Ref: FCC Class II Permissive change for FCC ID: 2A22Z-G300HPLUS

Applicant: Botslab Inc.

This is to request a Class II Permissive change for FCC ID: 2A22Z-G300HPLUS originally granted on 05/19/2026 (date).

1. Main board photo: Mainboard mechanical structure and board-side connectors are unchanged. RF-related PCB layout keeps identical.

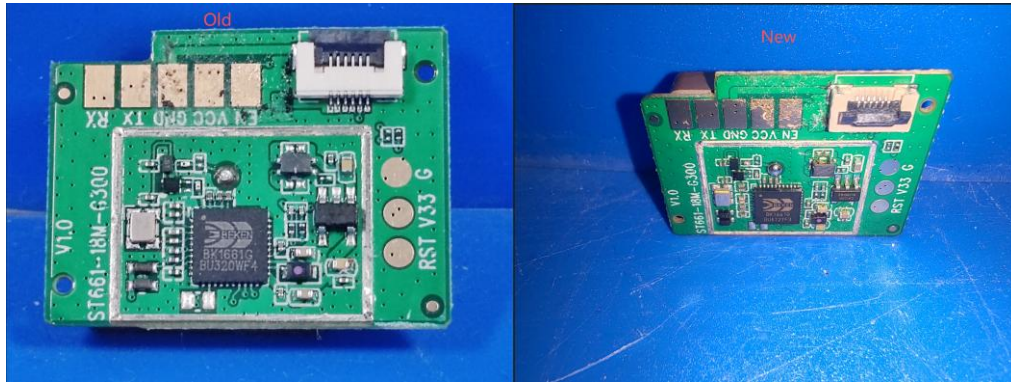
2. Camera module photo: Comparison between original IMX675 and alternative SC431HA1 camera sensor modules. Only one camera module will be populated per unit.

3. GPS sub-board photo: Comparison of original and revised GPS sub-board. Only GPS IC is replaced; sub-board PCB layout, connector and RF circuits remain unchanged.
